DEPARTMENT OF PLANNING & INFRASTRUCTURE

SUBJECT: MODIFICATION TO THE WOLLONGONG HOSPITAL REDEVELOPMENT (MP 10_0213 MOD 2)

PURPOSE

To determine a modification request (MP 10_0213 MOD 2) for the Wollongong Hospital Redevelopment. The modifications comprise changes to the façade, clarification on the height of the approved building, reduction in the number of bicycle spaces and the addition of a roof top plant room.

Figure 1: Photomontage perspective of the approved Loftus Street façade

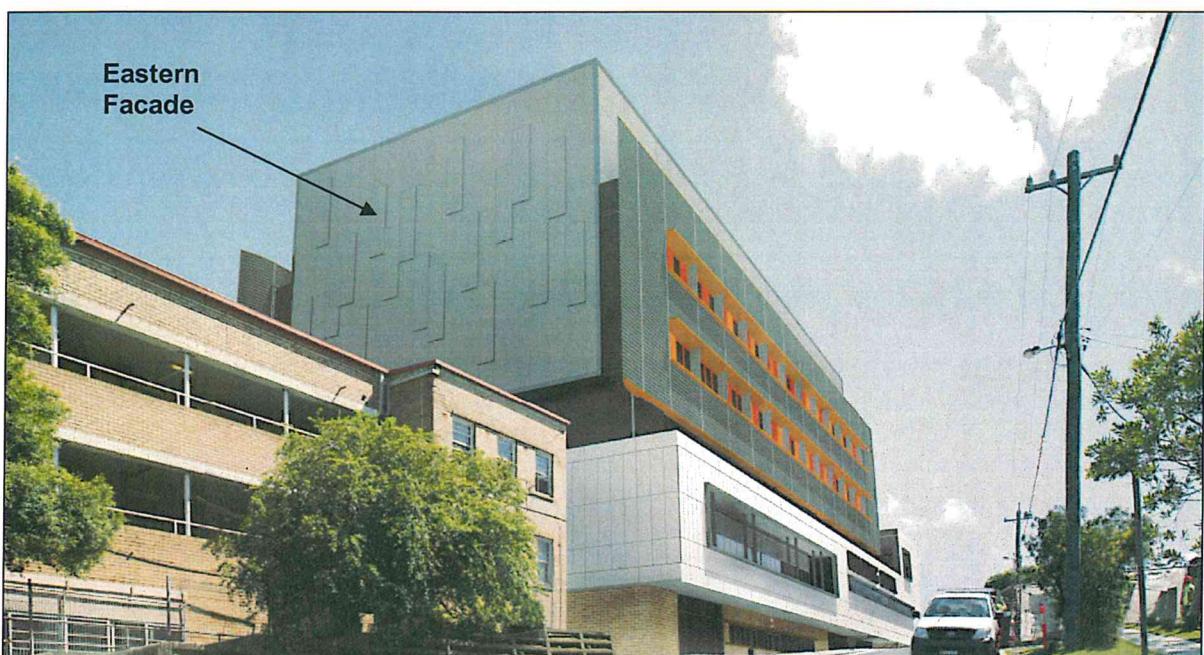
The proposed façade changes have the potential to result in a more visually intrusive built form by accentuating the visual mass of the building given the more minimalistic approach to the modulation and articulation of the façade (see **Figures 1 and 2**). The revised design removes vertical elements, including a reduction in the openings, blade walls, material changes, such as glazing and louvres, which provided visual interest along the lengthy Loftus Street facade. The proponent has simplified the design to reduce ongoing maintenance costs associated with cleaning of the facades and to reduce construction costs.

The department considers the revised design of the lower levels of the building, with an increase in the use of brick, provides a more sympathetic response to the adjacent heritage item and therefore can be supported. The revised design of the Loftus Street elevation maintains a visual separation between the podium and upper levels by setting back the upper levels and providing distinctive colour palettes for the two modulated elements (see **Figure 2**). A further setback of the plant level is also provided to minimise the bulk along the Loftus Street elevation. The department considers the revised design acceptable as the visual separation and projecting corrugated metal façade with orange fibre cement panels and projecting awnings provide visual interest along the extensive façade. The additional setback of the plant level also reduces the massing of the building.

The eastern elevation of the building has also been simplified by removing the glazing and vertical articulation, resulting in a solid form (see **Figure 2**). The department accepts that due to the functions located behind this elevation (predominantly fire stairs and plant) it would be unreasonable to require costly glazing treatments and the like to be provided. The department considers the projecting panels that have been incorporated in the design

Figure 4: Approved southern elevation

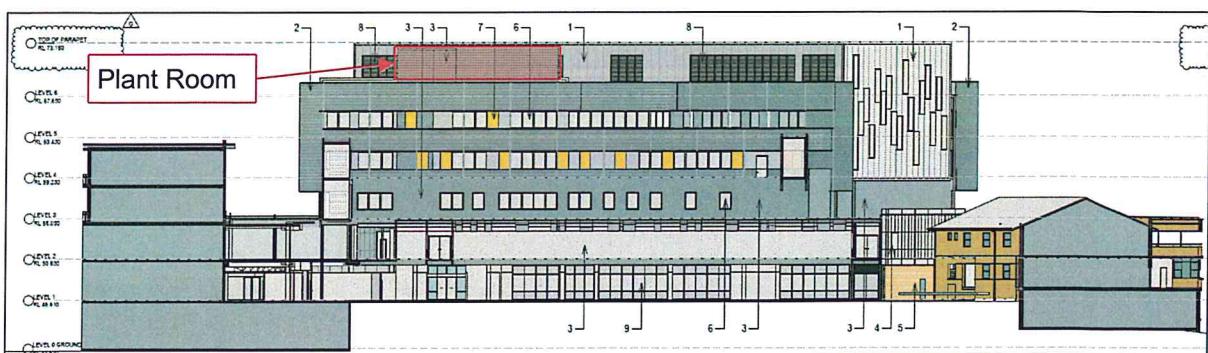
The department considers the proposal for an additional plant room to the southern wing to offset the reduced size of the plant room of the northern wing (see **Figures 4** and **5**) acceptable given it is located internally and is not visible from the public domain. The proposed changes would not have any view impacts and the height would be the same as the height of the plant room of the northern wing.
